GROUP BOD	MODEL 2017-2018MY Niro (DE P/HEV)
	NUMBER 186	DATE November 2018
TECHNICAL SERVICE BULLETIN		
SUBJECT: SERVICE ACTION: OUTSIDE DOOR HANDLE COVER REPLACEMENT (SA361)

This issue number is SA361.

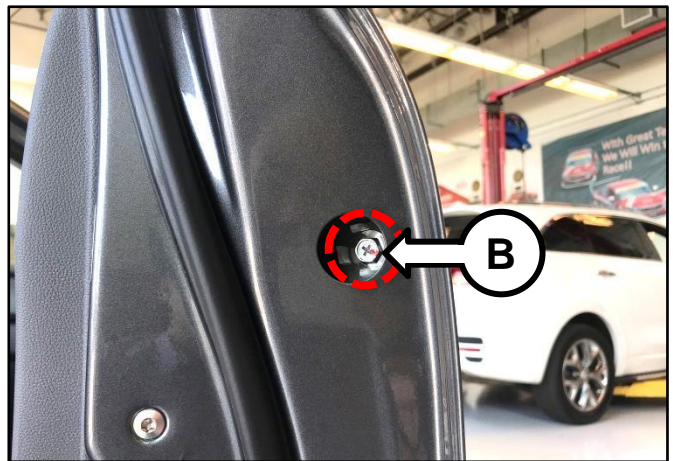
1. With the door open, remove the screw cover (A).

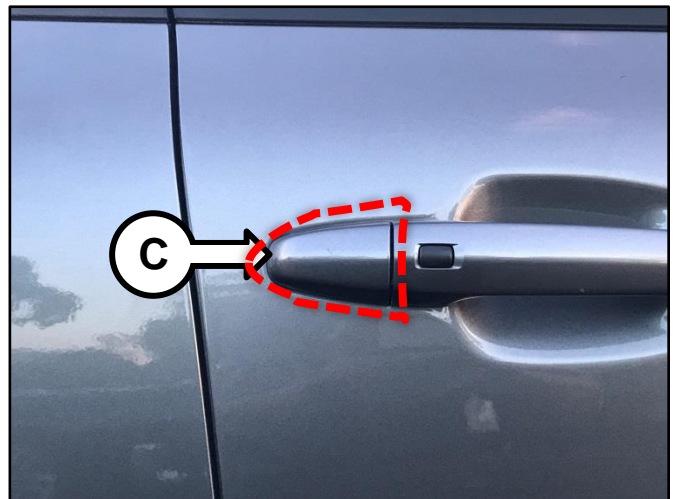
2. Carefully remove the outside door handle cover retaining screw (B).

3. Remove and replace the outside door handle cover (C) with the improved part.

4. Reinstall the retaining screw (B) and cover (A) in the reverse order of removal and then confirm proper door handle operation and fitment. **NOTE:** Be careful not to over-torque the retaining screw (B).

Tightening torque: 2.9 - 4.3 lb.ft (3.9 - 5.9 N.m, 0.4 - 0.6 kgf.m)
